RE: Geotechnical Third Party Review  
Old Longview Dam Rehabilitation Project  
Old Longview Dam  
Lee's Summit, Missouri  
Terracon Project No. 02185014

Old Longview Dam Rehabilitation ■ Lee's Summit, Missouri

March 2, 2018 ■ Terracon Project No. 02185014

**Photo 2- Upstream face rock "erosion control"**

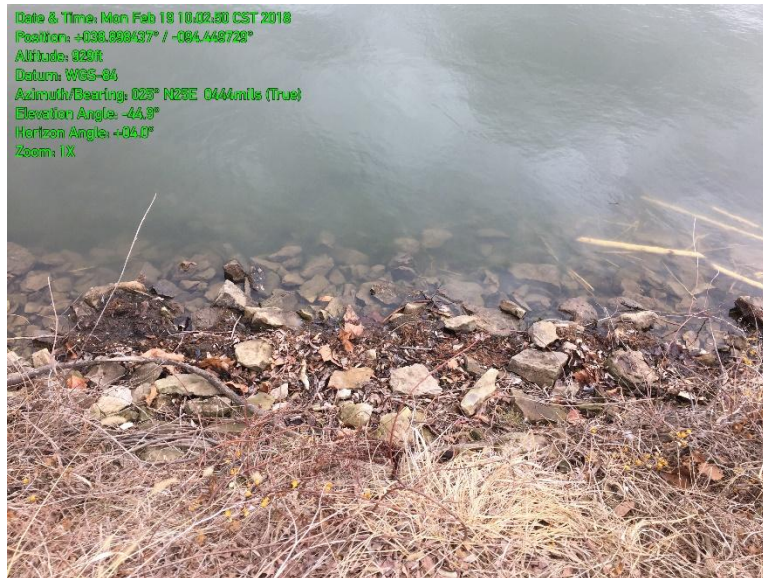
The upstream face appears to have rock fragments placed on it to control erosion (Photo 2). The freeboard area over the water surface does not appear to have any rock on its face and has experienced significant erosion (Photo 3).

Riprap- Photos 2 and 3 indicate the that upstream crest of the dam is eroding. Also, the rock fragments that were used for erosion control on the upstream side of the dam, do not have the size or durability to be used as Rip Rap per current Standard of Practice. This rock lacks the durability and size to provide adequate protection against wave action of the water.

The final restoration design should include adequate rip rap erosion protection along the upstream dam face. The final geotechnical design for any buttress fill or raising the crest of the dam should include toe keys/drainage and benching recommendations/details.

**Photo 4- Primary spillway and outlet works**

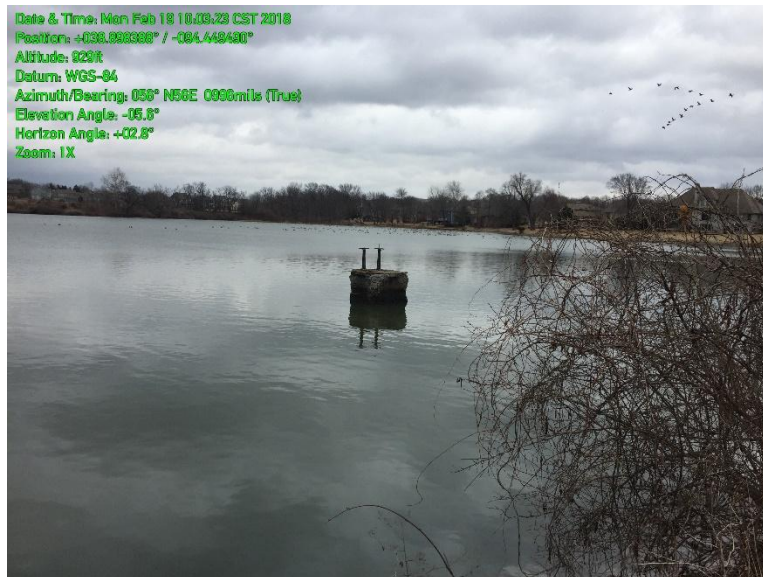
The primary spillway and outlets works appear to be in very poor condition, and is only accessible by boat, as there is no access walkway from the crest (Photo 4). The Terra Technologies report states that the outlet works valves and the spillway are inoperable. They could not find the outlet for this system, and Terracon could not locate the outlet during our site visits.
